Subject: Response to Preliminary Adequacy Review
Application Amendment #5
Mine Land Reclamation Permit M-1977-300, Schwartzwalder Mine, Golden, Colorado

M-1977-300 APPLICATION AMENDMENT #5, COMMENT AND RESPONSE SUMMARY TABLE		
COMMENT NO.	COMMENT	RESPONSE TO COMMENT
1	<u>Exhibit B- Index Map (Rule 6.4.2):</u> Please provide an updated index map showing the regional location of the affected land and all roads and other access to the area. A standard U.S. Geological Survey topographic quadrangle or equivalent is acceptable. Scale criteria need not be followed for this map.	Revised as requested. The U.S. Geological Survey topographic quadrangle for Ralston Buttes Colorado has been included in Exhibit B as "Figure B-1. Index Map".
2a	<u>Exhibit C – Pre-Mining and Mining Plan Map(s) of Affected Lands (Rule 6.4.3):</u> Please provide an updated Exhibit C-1 map with the following revisions: Per Rule 6.2.1(2)(e), please ensure the map is prepared at a scale that is appropriate to clearly show all elements that are required to be delineated by the Act and Rules. The acceptable range of map scales shall not be larger than 1 inch = 50 feet nor smaller than 1 inch = 660 feet. The scale of the

FIGURE C-1
AFFECTED LANDS

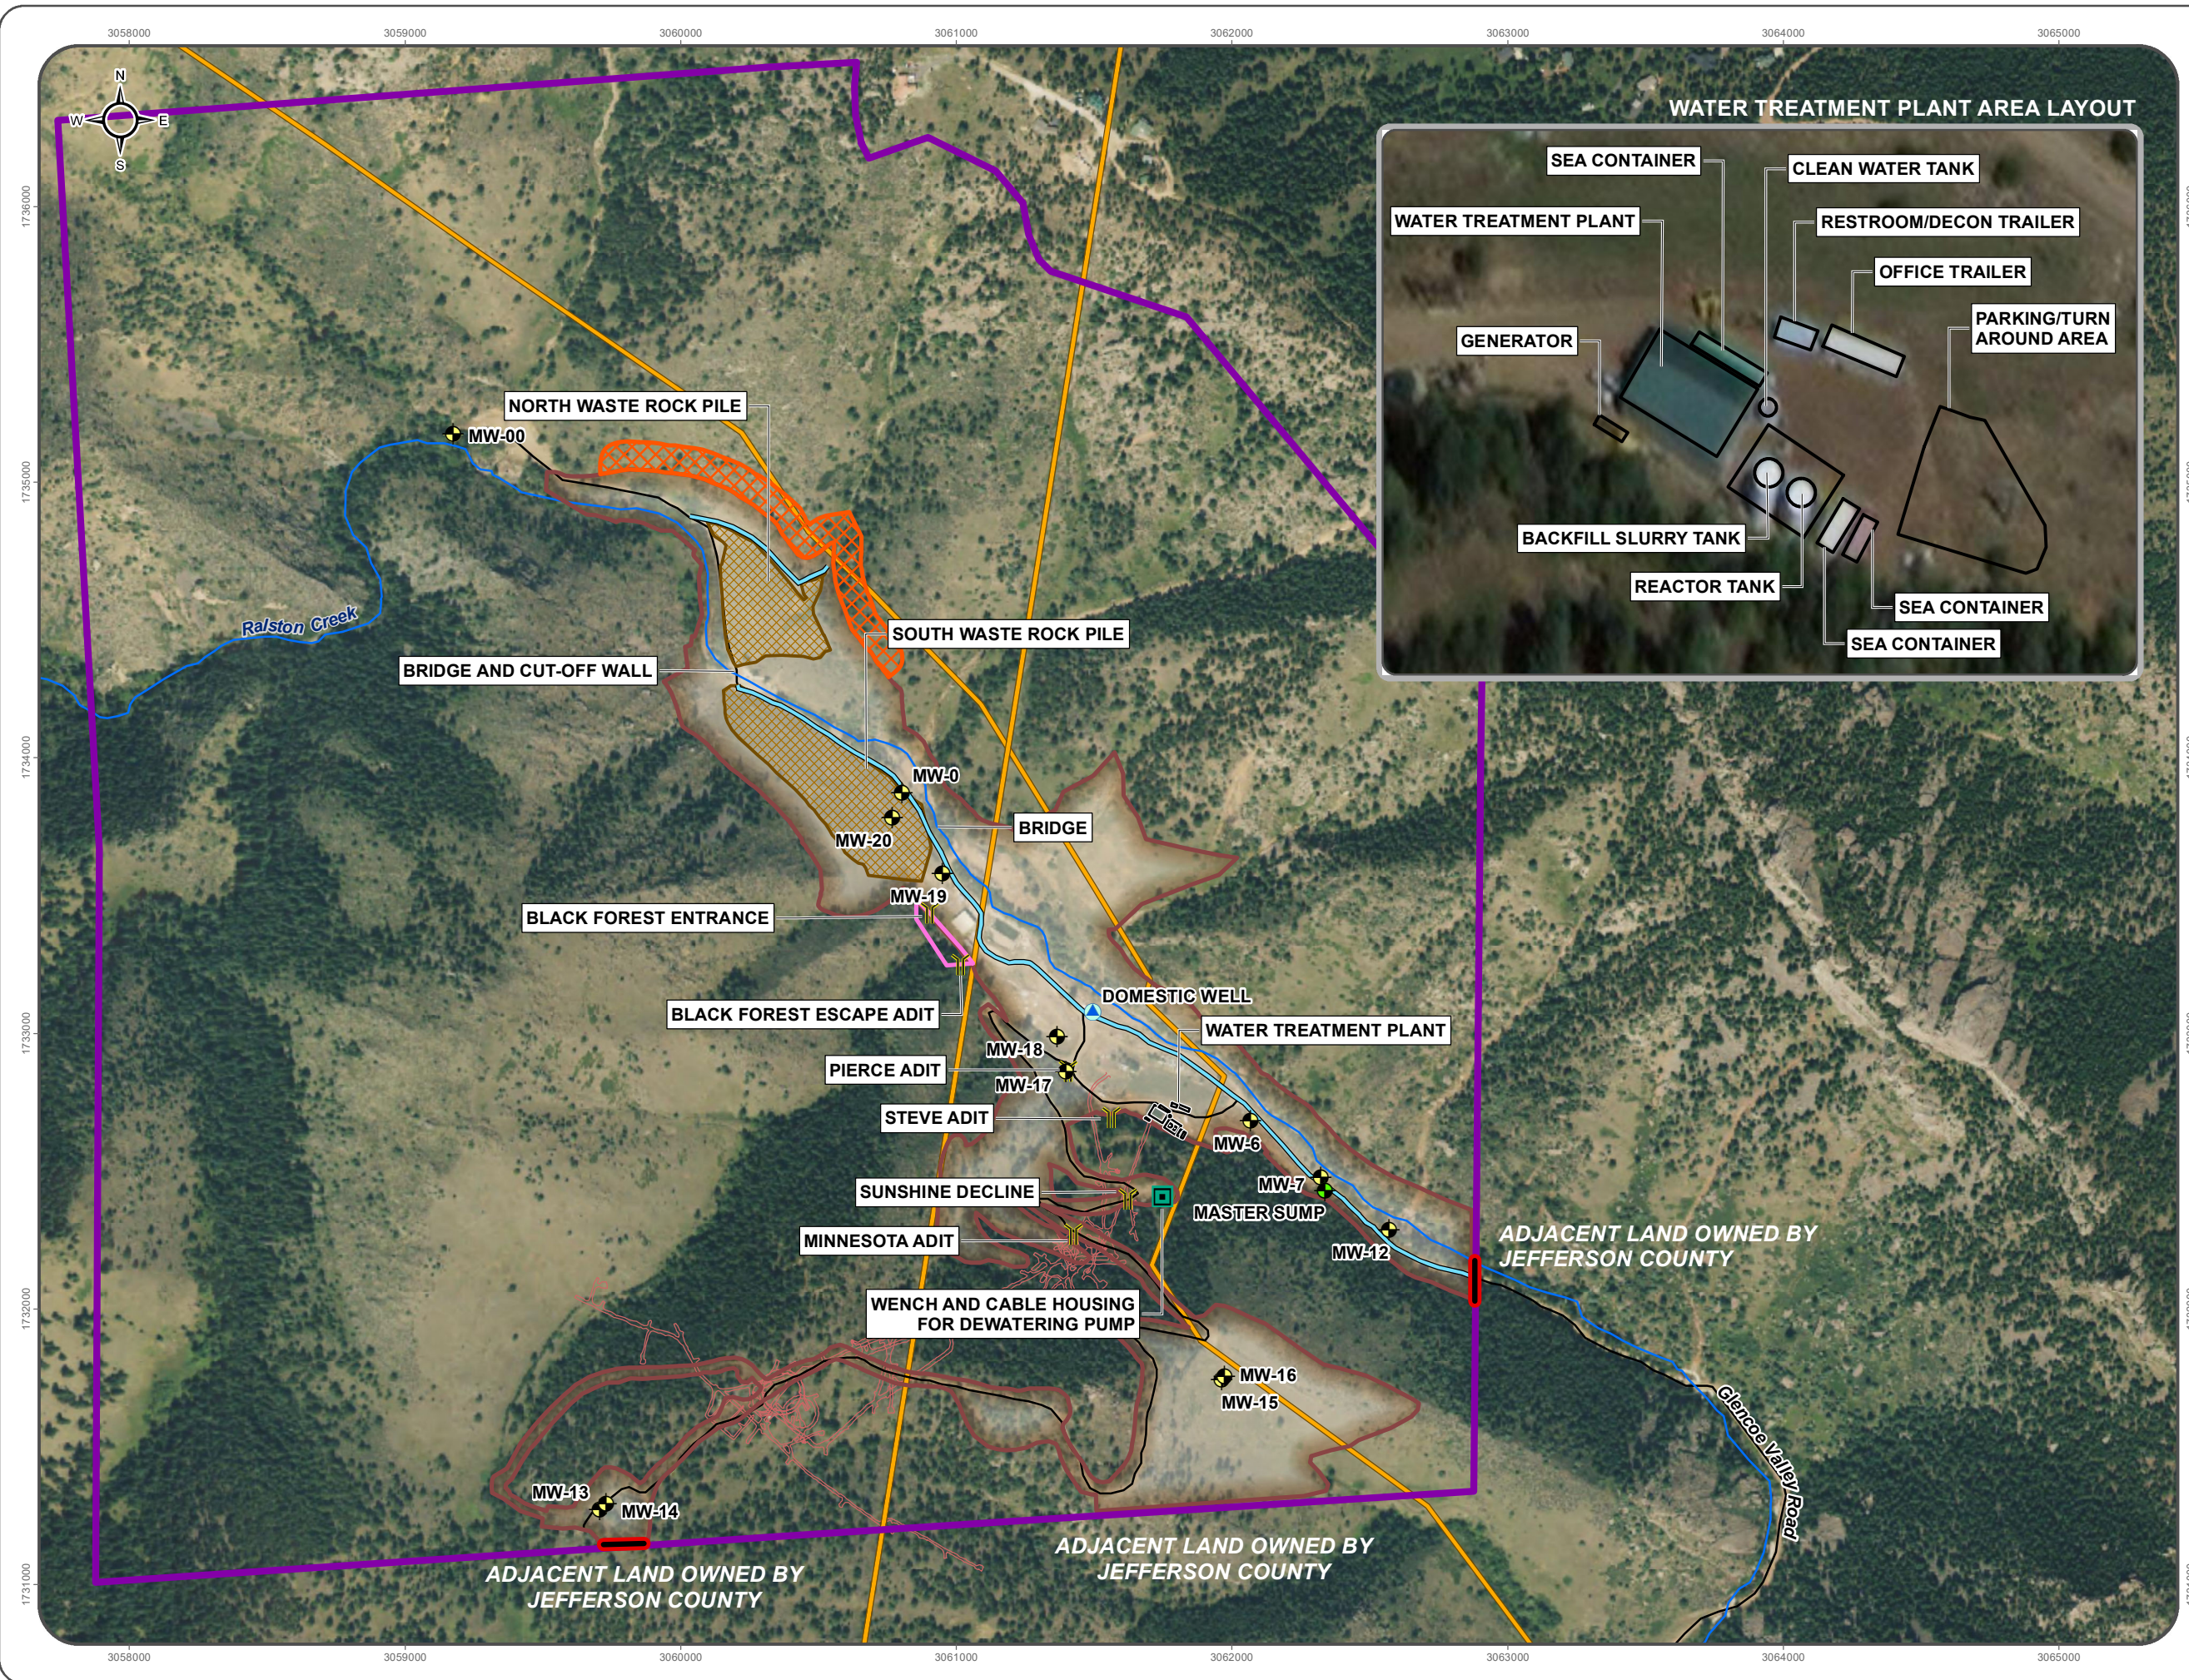
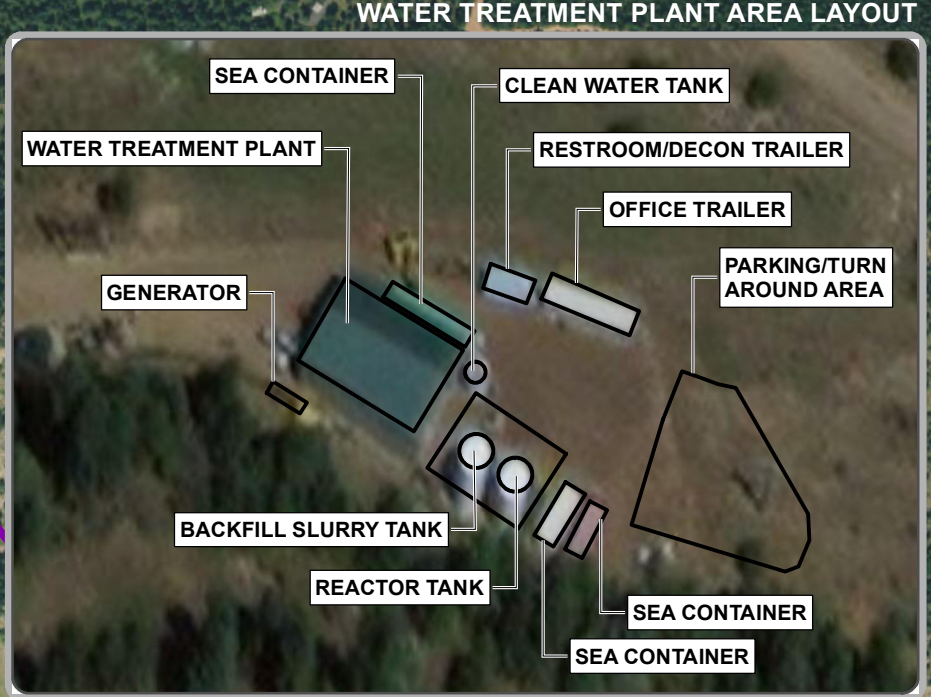
2b	<u>Exhibit C – Pre-Mining and Mining Plan Map(s) of Affected Lands (Rule 6.4.3):</u> Per Rule 6.4.3(a), please show all immediately adjoining surface owners of record. Since the operator owns the land surrounding the permit area except at its southern and eastern edges, the surface owner information is only required in these areas.	Revised as requested.
2c	<u>Exhibit C – Pre-Mining and Mining Plan Map(s) of Affected Lands (Rule 6.4.3):</u> Per Rule 6.4.3(b), please show the name and location of all creeks, roads, buildings, oil and gas wells and lines, and power and communication lines on and within 200 feet of the affected land/permit area. The operator has already labeled most of these features on the map, except for the power and/or communications lines which the Division has observed on site.	Revised as requested. Please note: no oil and gas wells or lines are present, and therefor not shown on the figure.

2d	<u>Exhibit C – Pre-Mining and Mining Plan Map(s) of Affected Lands (Rule 6.4.3):</u> Per Rule 6.4.3(g), please show the owner's name, type of structures, and location of all significant, valuable, and permanent	Revised as requested.

FIGURE F-1
RECLAMATION PLAN MAP

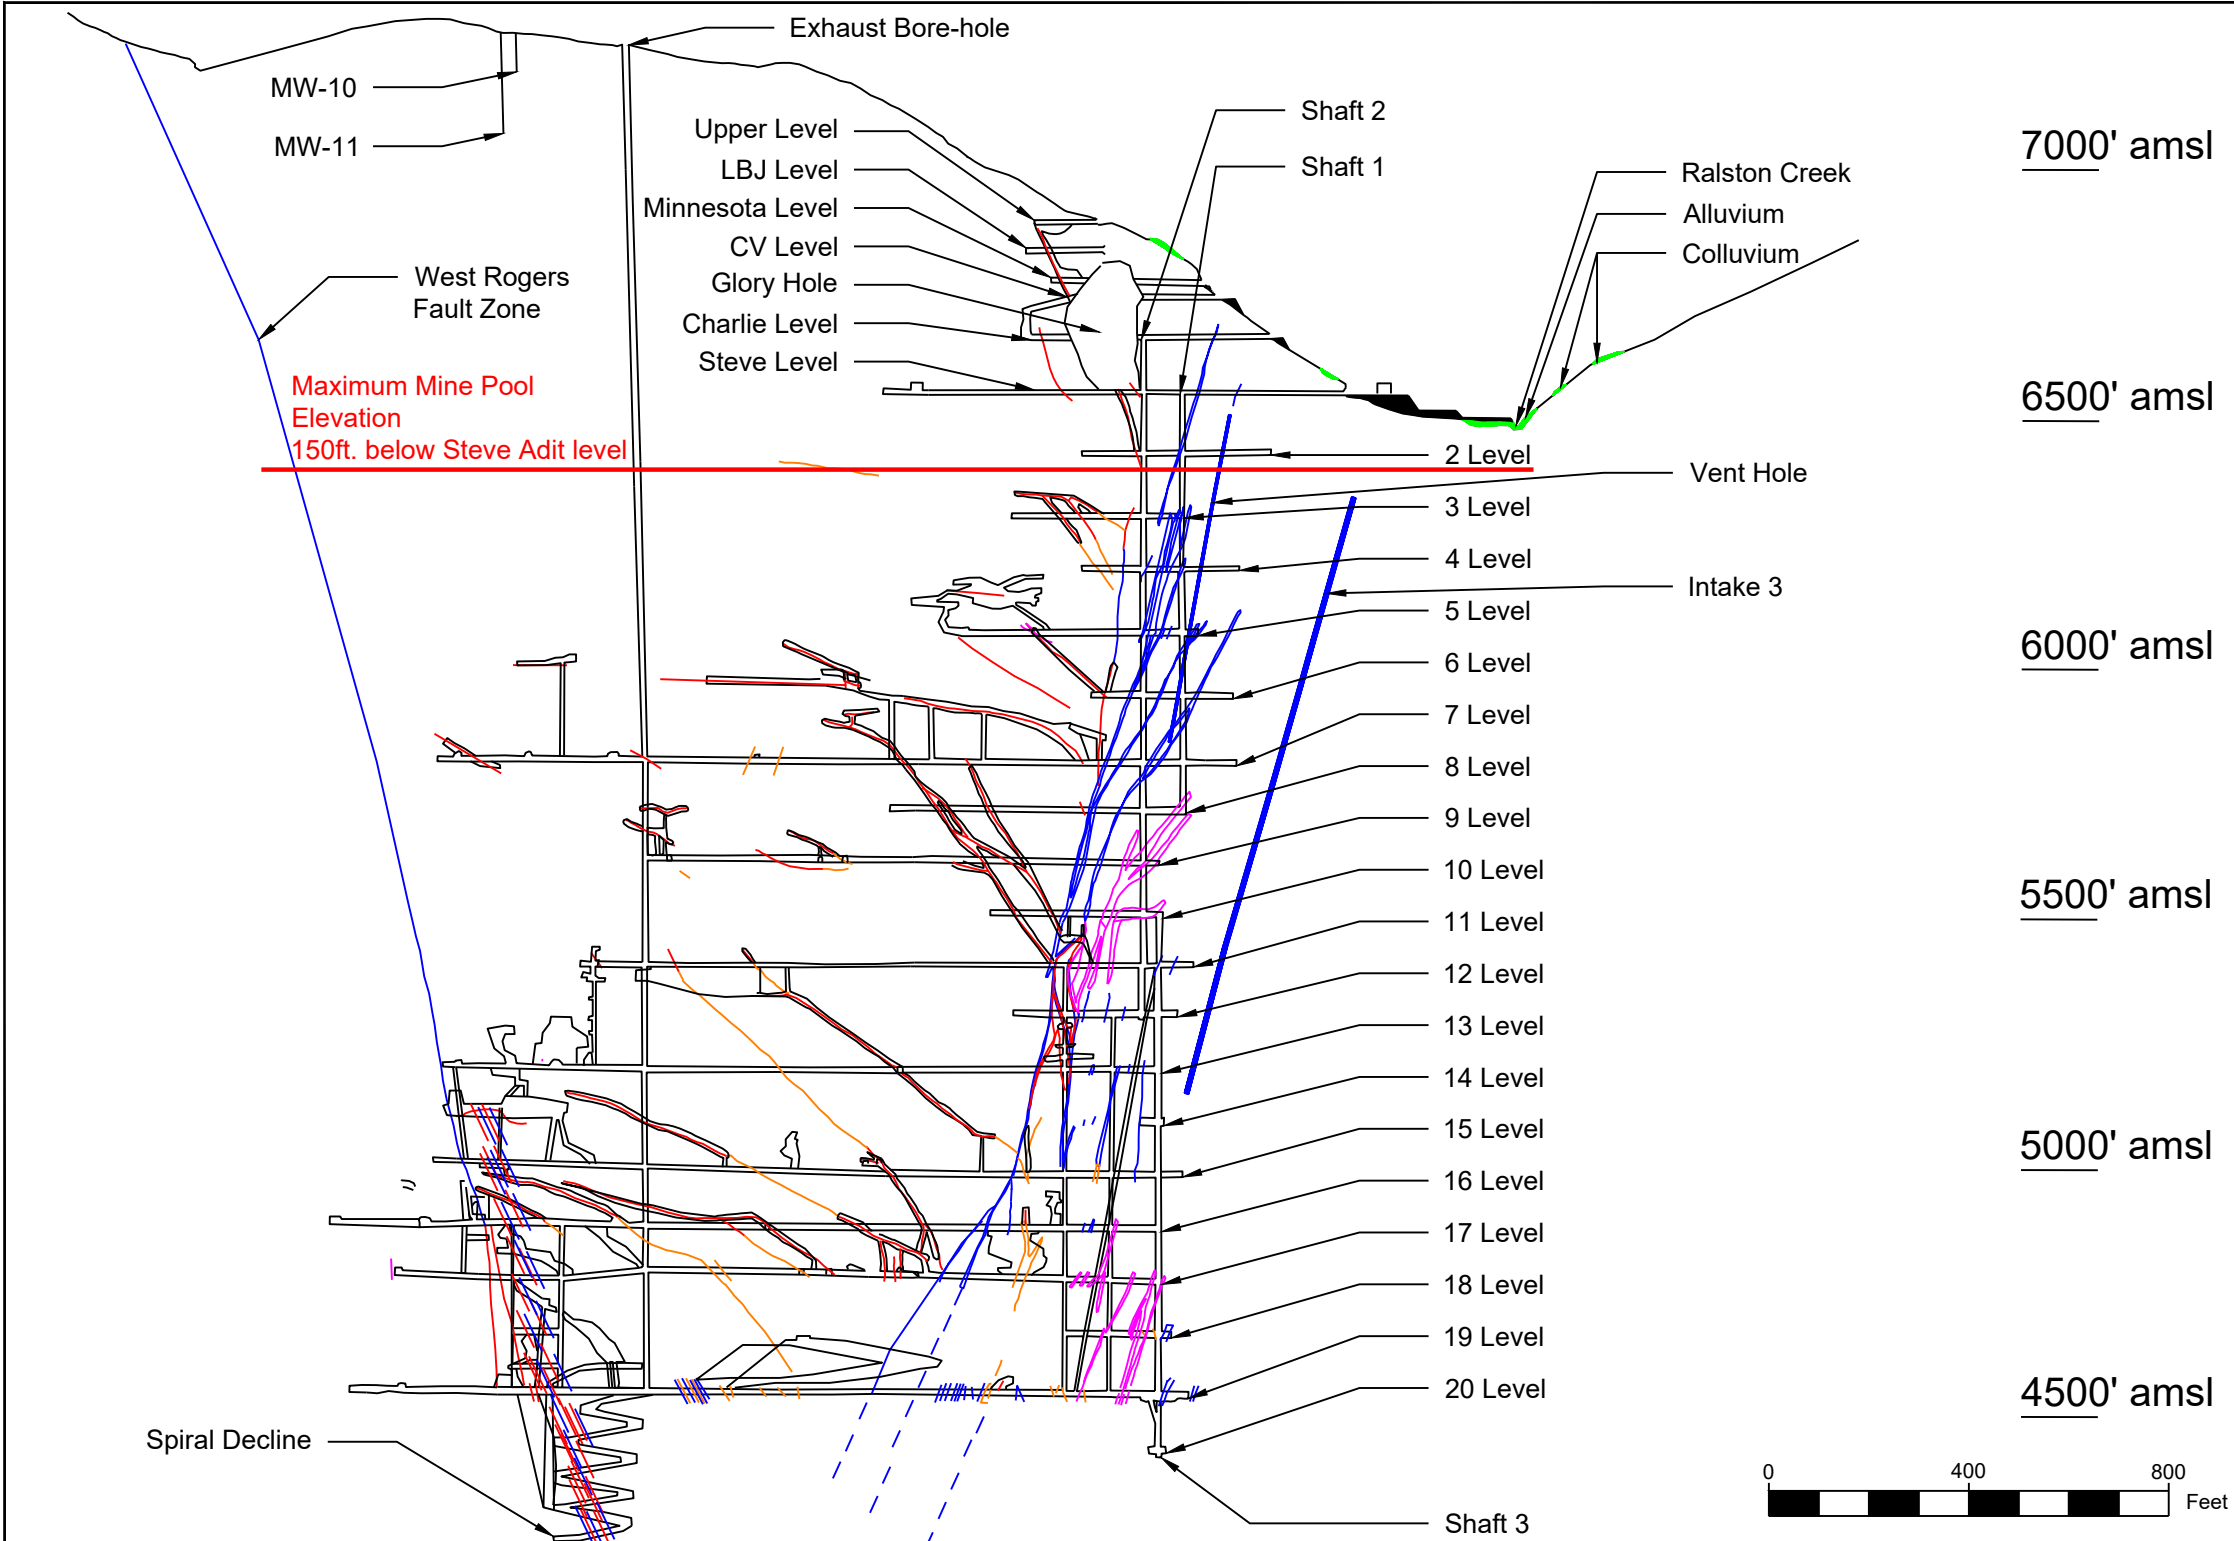
M-1977-300 APPLICATION AMENDMENT #5, COMMENT AND RESPONSE SUMMARY TABLE		
COMMENT NO.	COMMENT	RESPONSE TO COMMENT
6a	<u>Exhibit F – Reclamation Plan Map (Rule 6.4.6):</u> Please provide an updated Exhibit F-1 map with the following revisions: Per Rule 6.2.1(2)(e), please ensure the map is prepared at a scale that is appropriate to clearly show all elements that are required to be delineated by the Act and Rules. The acceptable range of map scales shall not be larger than 1 inch = 50 feet nor smaller than 1 inch = 660 feet. The scale of the map submitted is 1 inch = slightly more than 750 feet, which is a smaller scale than the required 1 inch = 660 feet. The scale of the map makes it difficult to assess the location of the permit boundary, the proposed expansion areas, and the reclamation proposed for affected lands, particularly for the proposed expansion areas. The Division recommends the map be revised to show less of the property boundary and more of the affected land/permit boundary to meet the scale criteria and to clearly show all elements required to be delineated.	Revised as requested.

6b	<u>Exhibit F – Reclamation Plan Map (Rule 6.4.6):</u>Per Rule 6.4.6(a), please show the expected physical appearance of the area of the affected land, correlated to the proposed reclamation timetable. The map must show proposed topography of the area with contour lines of sufficient detail to portray the direction and rate of slope of all reclaimed lands. The Division understands the operator is currently developing a final reclamation plan for the site that incorporates analyses of monitoring and testing programs conducted at the site as well as the final topography to exist after conclusion of the valley excavation project, and this plan will be proposed in a subsequent Amendment application (to be submitted in 3rd quarter of 2021). Therefore, please provide as much information on the map as available at this time, including approximate final slope gradients for disturbed areas (e.g., waste rock piles, valley disturbances, mesa disturbances), mine openings to be secured/sealed, structures to remain (including roads), and any areas to be retopsoiled and revegetated for final reclamation. The specific grading plan for the valley, including any changes to the current creek channel alignment, can be provided in a subsequent revision once this information is known.	Revised as requested.

COMMENT NO.	COMMENT	RESPONSE TO COMMENT
6c	<u>Exhibit F – Reclamation Plan Map (Rule 6.4.6):</u> Per Rule 6.4.6(b), please ensure the map portrays the proposed final land use for each portion of the affected lands.	Revised as requested. A note has been added to Figure F-1 affirming that all affected lands shall be reclaimed for wildlife habitat.
7	<u>Exhibit G – Water Information (Rule 6.4.7):</u> Please provide demonstration that disposal of radionuclide-impacted alluvial valley soils into the Black Forest Mine will not directly affect surface or groundwater systems. This demonstration should include, at a minimum, a cross-section showing elevations of the Black Forest Mine with respect to elevations of the Minnesota “CV Glory Hole”, the Steve Level, the approved maximum mine pool level (150 feet below Steve Level), and the creek channel, and an explanation of how the material placed inside the Black Forest Mine is not expected to contaminate surface or alluvial groundwater in the Ralston Creek stream shed.	Revised as requested. Exhibit G has been revised to include the requested cross-sectional figure and a discussion on how disposal in the Black Forest is expected to affect the water quality in the shallow alluvium and Ralston Creek.
